Wiltshire Council Planning Consultation Response

URBAN DESIGN

Application No: PL-2026-04078

Proposal: Approval of reserved matters (scale, layout, appearance and landscaping)
pursuant to Outline Planning Permission 21/01004/OUT

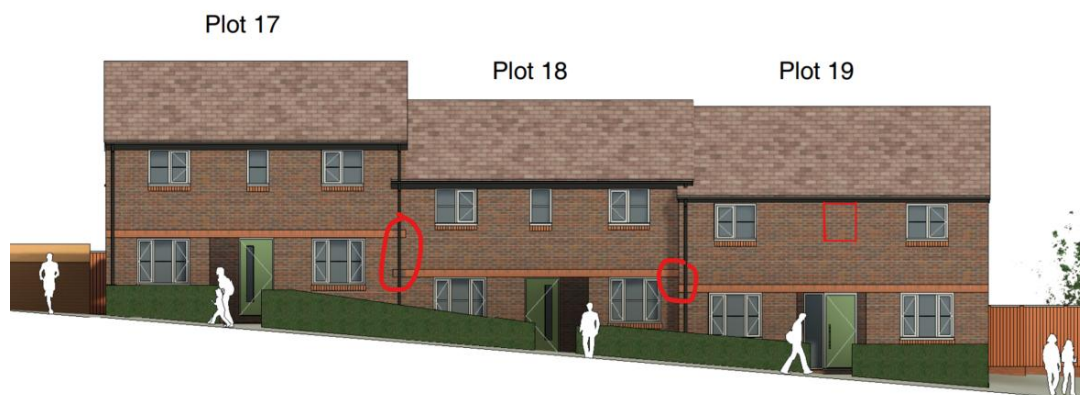
Whilst the overall landscape approach is strong, it would be beneficial to explore opportunities for additional street trees. Increased greenery would help further soften the appearance of parked vehicles and hard surfacing, particularly at the southern end of the site. One possible approach could be to locally reduce the highway in places, as can be seen in the scheme below.

Boundary treatments fronting public areas are generally proposed as robust masonry walls, which is welcomed and aligns with the recommendations of the Wiltshire Design Guide. To further enhance visual coherence across the development, consideration should be given to tailoring boundary wall materials to reflect the architectural character of the adjacent dwellings. For example, the wall associated with House Type 8 currently appears disconnected visually from the building it serves due to the differing material palette. In this instance, the use of flint and brick detailing within the wall would provide a stronger visual relationship with the dwelling, and contribute to a more cohesive and considered streetscape.
